**Furniture RFP - Addendum 02**

**Project Name:** MCPLD-Mesa County Public Library, Clifton Branch Library  
**Wember Project Number:** 2019.37  
**Issue Date:** March 6, 2023  
**Purpose:** Furniture RFP Addendum 02

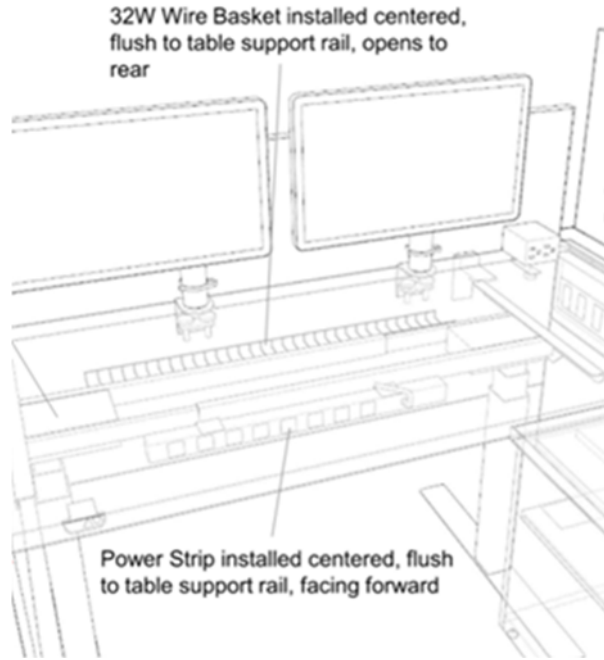
<b>Question 14</b>	<b>TS pedestal must be 22"D to have cushion top. Do you want to keep it 19"D without the cushion or change to 22"?</b>
	Change to 22" to have cushion top.
<b>Question 15</b>	<b>Can you please clarify the power needs for WS01.</b>

Convenience outlet on top of the worksurface, then a power strip with surge protection as indicated in spec underneath. Cords from the convenience outlet, monitors, docking station will waterfall over the edge and between the gap in the top and the modesty to the underside of the table. Those items and the height adjustable table power will also be plugged into that power strip. The only cord that will need to go down the leg and be plugged in is the power strip (and possibly data cord). All excess cords should be placed in the basket. Here is an example diagram if needed:
